**FINAL**  
**Environmental Impact Report**  
**Hidden Canyon Residences and Preserve Project**  
**City of Pleasanton, Alameda County, California**

**State Clearinghouse Number 2019080461**

Date: April 15, 2026

**MM AES-4a Adhere to Design Review Process and Standards**

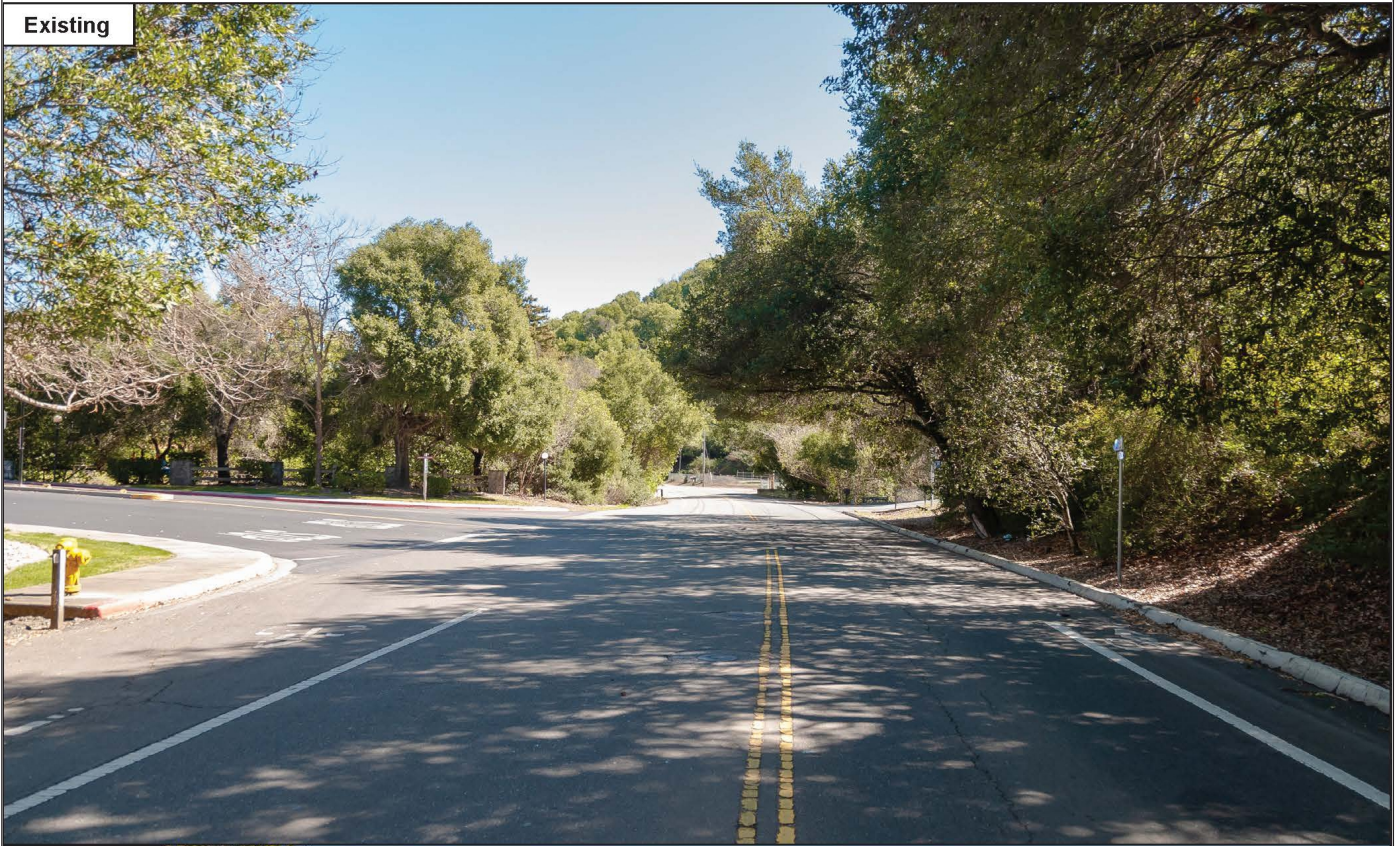
Chapter 2, Project Description, Exhibit 2-7b of the Draft EIR is mislabeled as Dublin Canyon Road Project Entrance but actually shows the existing Dublin Canyon Road and Canyon Meadows Drive intersection as well as a simulation of what the intersection would look like after project implementation. As shown, there would be a significant improvement in visibility as well as the addition of a traffic signal, striping and markings to enhance safety for motorists, bicyclists, and pedestrians. Section 5, Errata, includes the corrected Exhibit titles. This comment is included in the administrative record and will be provided to the decision-makers for review and consideration. The comment did not provide new, substantial evidence with respect to the disposition of significant environmental impacts evaluated in the Draft EIR. Therefore, no further response is required.
